UNITED STATES ENVIRONMENTAL PROTECTION AGENCY

July 29, 1992

COMMENTS AND OBSERVATIONS
ON THE DRILLING ACTIVITIES PERFORMED BY
EPA's TAT CONTRACTOR
AND SUBCONTRACTED DRILLER
DURING THE PERIOD OF
JUNE 23 THROUGH JUNE 27, 1992

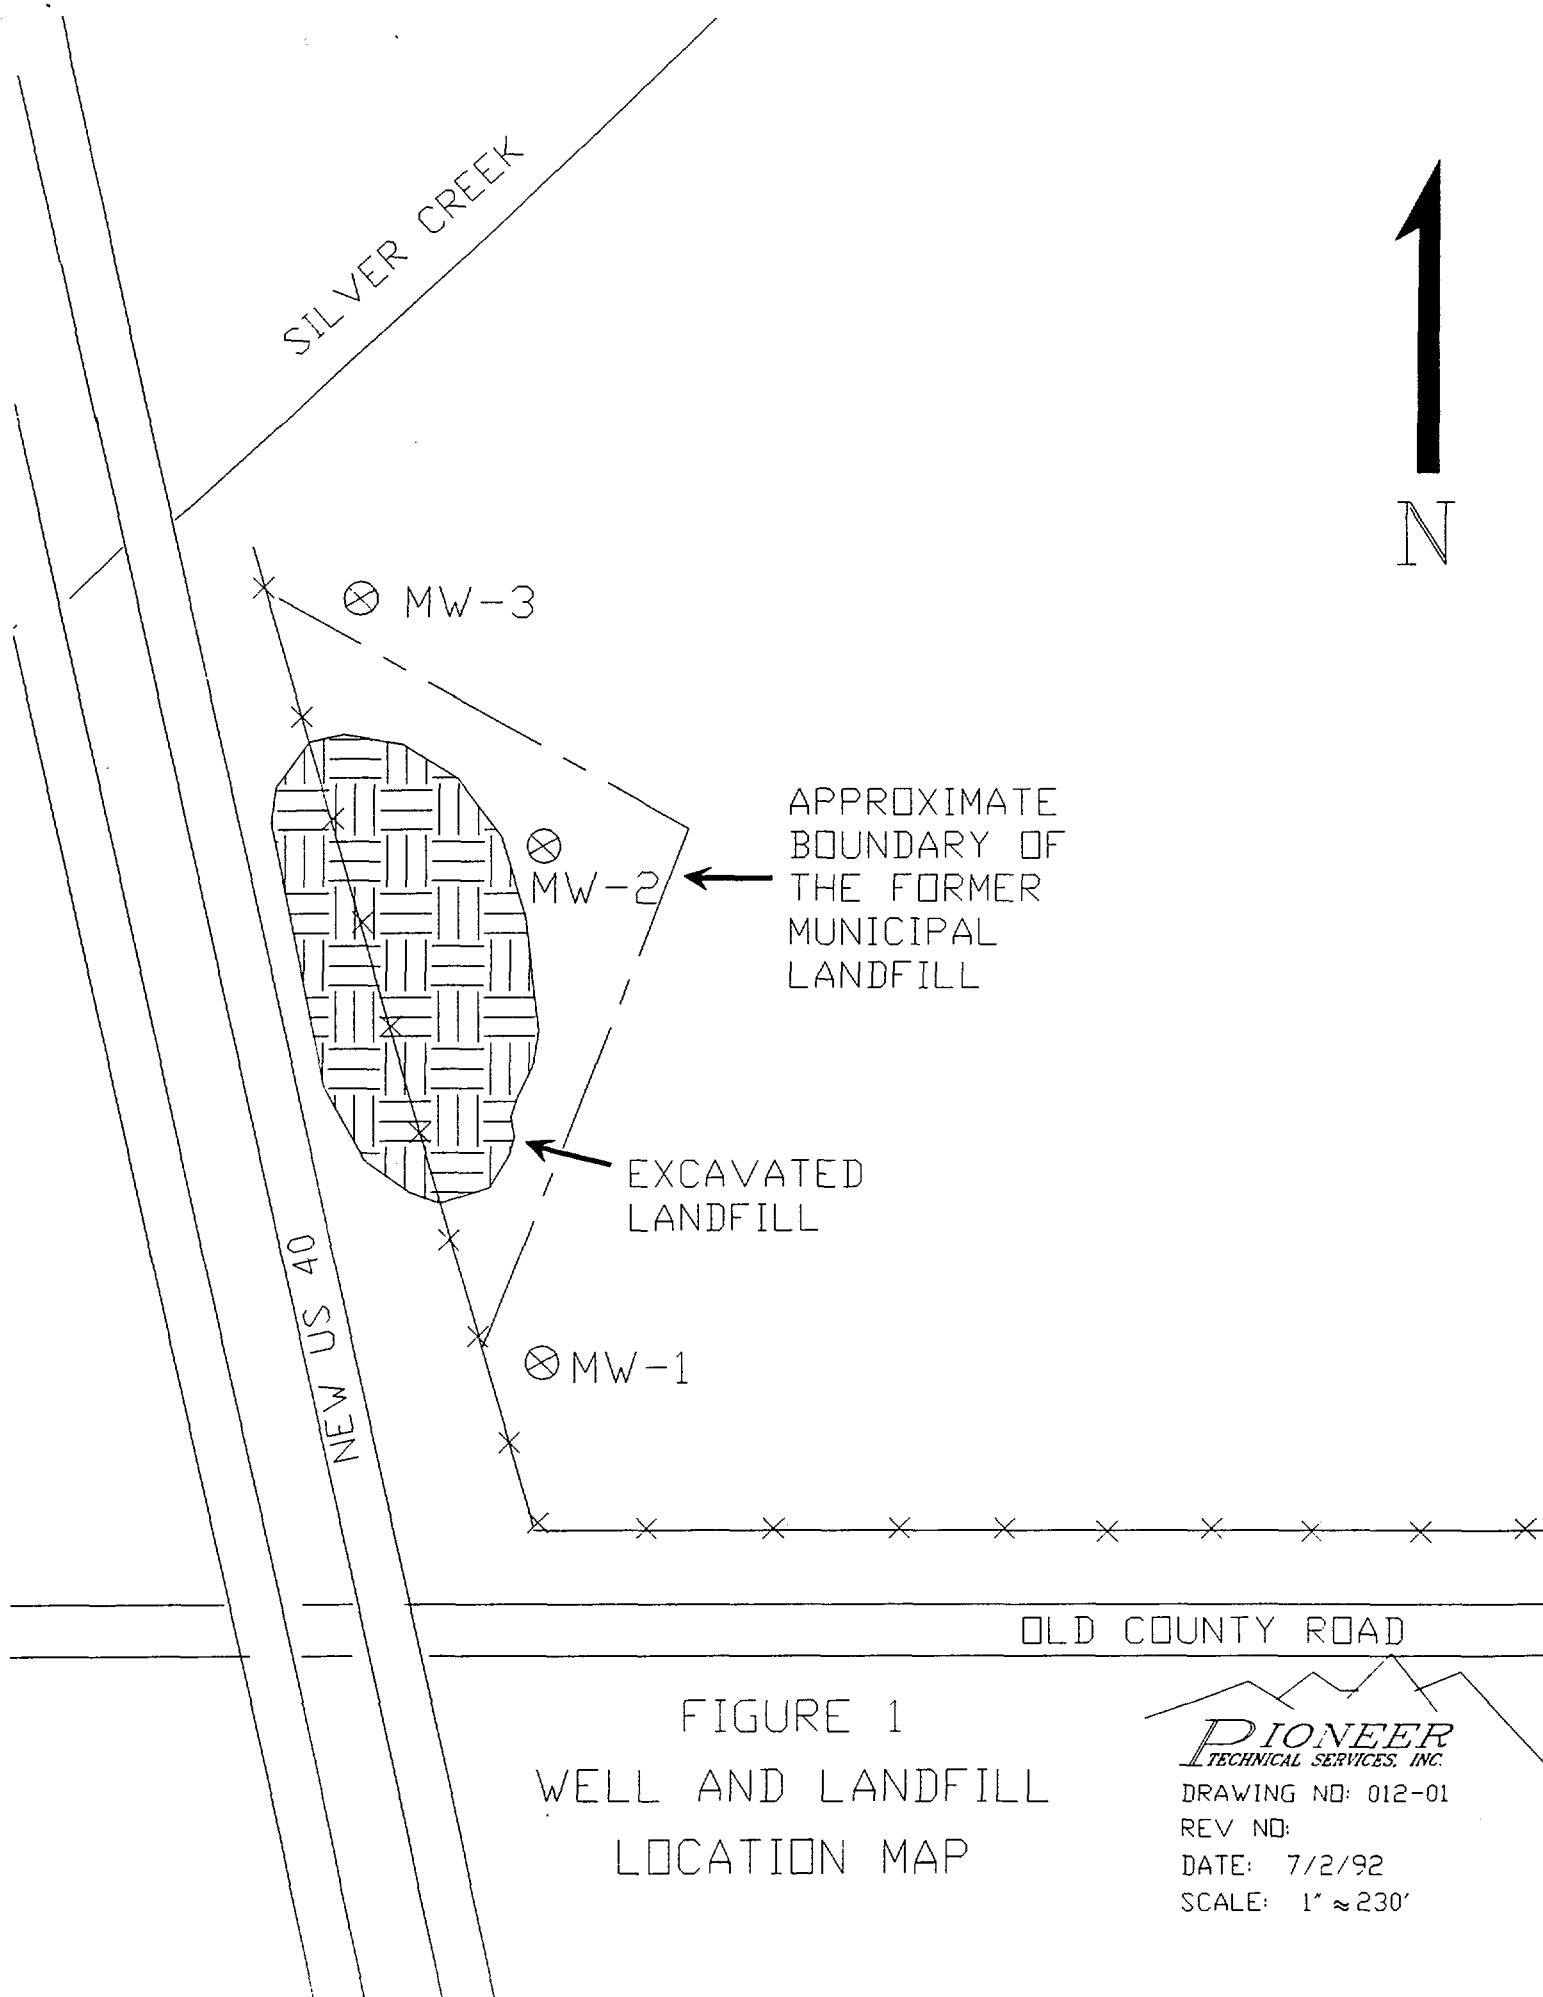
A) MONITORING WELL MW-2 WAS INSTALLED WITHIN THE BOUNDARY OF
THE HISTORIC PARK CITY LANDFILL, CONTRARY TO USEPA GUIDANCE.

The most blatant violation of EPA guidance in the drilling of these monitoring wells was the placement of well MW-2 within the boundary of the historic landfill (see Figure 1). USEPA direction is clear - drilling directly through municipal landfills is to be avoided in order to protect underlying groundwater, and for obvious safety considerations; rather, drilling is to be conducted off of the actual landfill and downgradient from it. Prior to drilling, the TAT was advised by the property owner (UPCM) that the location selected for MW-2 was within the former landfill boundary. For whatever reasons, the TAT declined to relocate the well 100 feet to the north, out of the former landfill. After drilling five to ten feet, drill cuttings and split-spoon sample cores showed that the borehole was obviously within the landfill.

At this point, the proper procedure would have been to properly abandon the borehole, move off the landfill, and drill a new borehole in a safer location; however, the TAT persisted with drilling in the landfill. If TAT had adequate training and experience in hydrogeology, they would have anticipated the potential for problems arising from drilling through a landfill, and chosen to drill elsewhere. TAT's lack of experience and refusal to follow USEPA policy, resulted in one of the most serious monitoring well installation calamities possible (described below).

FIGURE 2
GEOLOGIC CROSS SECTION
AND LANDFILL MONITORING WELLS

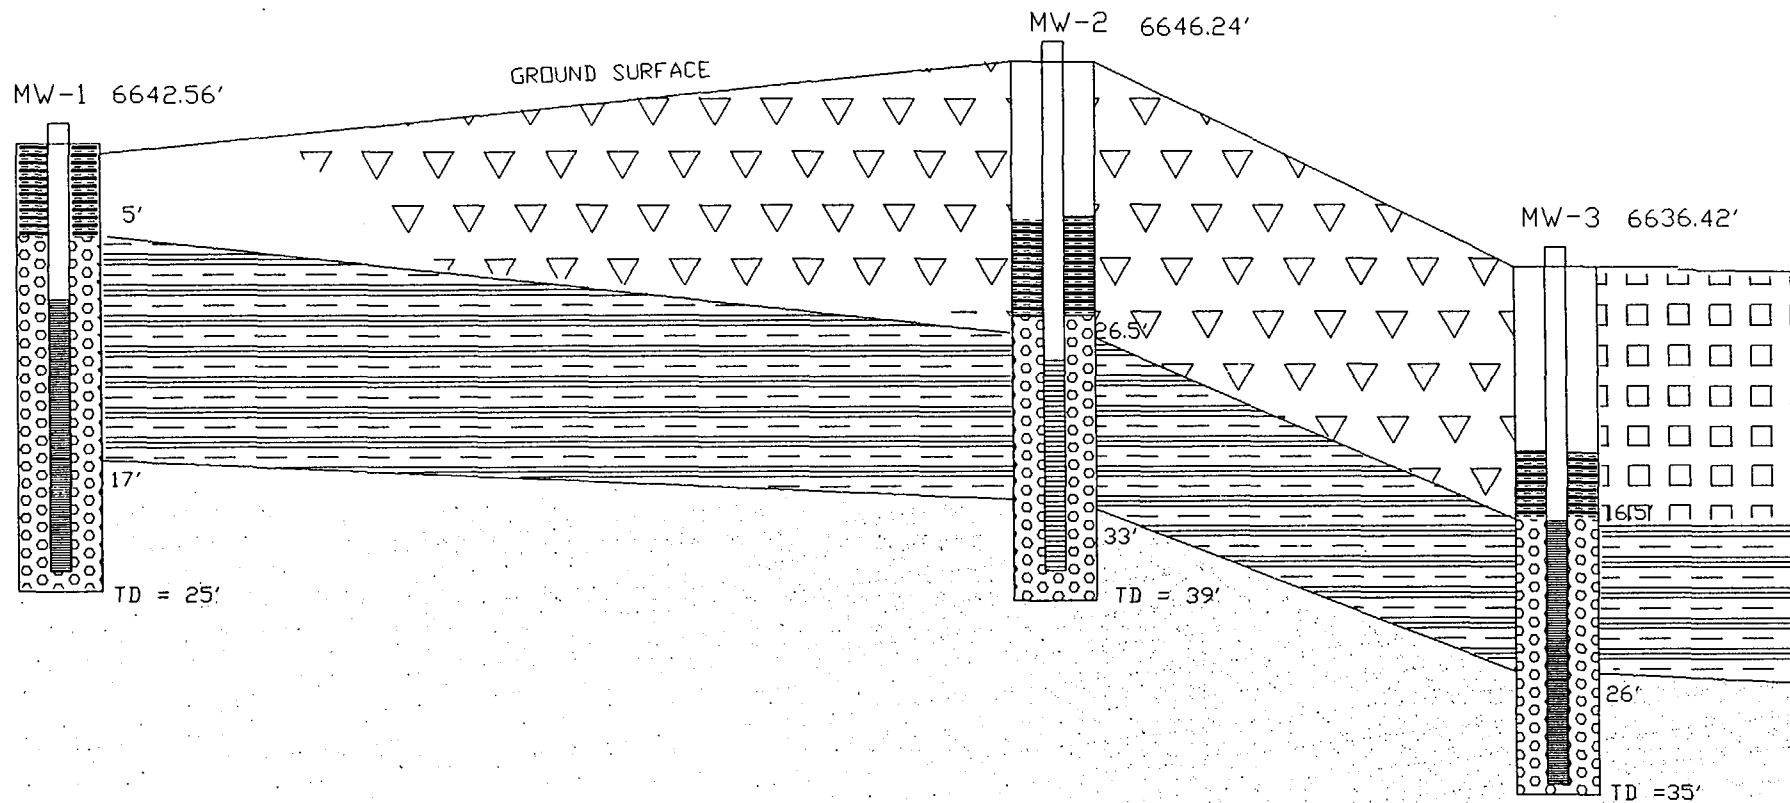
After ill-advisedly locating well MW-2 within the former landfill (discussed above), drilling commenced. For whatever reason, the TAT did not closely monitor the drill cuttings from the borehole; however, UPCM's hydrogeologist was because of the geology observed at MW-1 and concern about breaching the aquitard underlying the landfill. At 25 ft bgs, a two-foot split spoon core revealed six inches of the aquitard (a reddish-brown clay) in the bottom of the core barrel, clearly showing the top of the aquitard to be at 26.5 ft bgs. The TAT erroneously recorded the top of this unit at 25 ft bgs. Drilling continued (slowly) and water was encountered between 34 and 35 ft bgs. The drilling was halted at 39 ft bgs and well completion activities began.

At this point, serious errors in judgment and perhaps criminal negligence, caused the completion of well MW-2 to be entirely inappropriate, if not illegal. First, 10 feet of screen were placed in the well, bringing the screened section up to 27.5 ft bgs, very close to the top of the aquitard unit. Then, the filter pack was brought up to 26 ft bgs, above the aquitard. The bentonite seal placed on top of the sand was intended to plug the aquitard; however, due to careless geologic logging, it completely missed the aquitard and provides no such seal. The formerly continuous barrier between the landfill materials and groundwater has been breached by the drilling and not repaired during well construction. Water level measurements on subsequent days show clearly that the underlying water is under pressure and has risen up the borehole to exactly 26.5 ft bgs, the top of the aquitard. The underlying groundwater is now flowing up the well under pressure, out through the filter pack along the top of the clay aquitard and into the base of the formerly dry landfill. When this water discharges from the base of the landfill, either as springs or to Silver Creek, it will be contaminated by whatever is in the landfill.

- secondly, careful geologic logging would have shown the aquitard unit to be between 26.5 and 33 feet bgs, and hence, no need to screen above 33 ft bgs; and,
- finally, the placement of screen and sand up to the base of the aquitard (33-38 ft bgs) and bentonite within the aquitard (26-33 ft bgs) could have maintained the integrity of the natural barrier between the landfill materials and the underlying groundwater system.

The third well, MW-3, was moved further north at the urging of UPCM. During drilling, construction debris was encountered, but no municipal landfill wastes. This well encountered the same hydrogeology and was similarly misconstructed; however, the results are not as critical. The same aquitard (reddish-brown clay) was encountered in MW-3 at 16.5 ft through 26 ft bgs and water was again encountered beneath it. Instead of completing the well with the screened section at 26 to 34 ft bgs, TAT decided to place 15 feet of screen in this well, 5 feet into the aquitard. Filter pack was again placed in the borehole up to the top of the aquitard (16.5 ft bgs), and the bentonite seal above that, again missing the aquitard and not sealing the borehole. The result of this is again, the upward migration of formerly confined groundwater into the construction debris and eventually out of the filled area to surface water.

In any event, the serious nature of the well construction disaster described above is at least unprofessional and at worst illegal. I recommend that all of these wells be properly abandoned as soon as possible. It is especially critical that MW-2 be plugged so that it does not continue to flood the landfill.
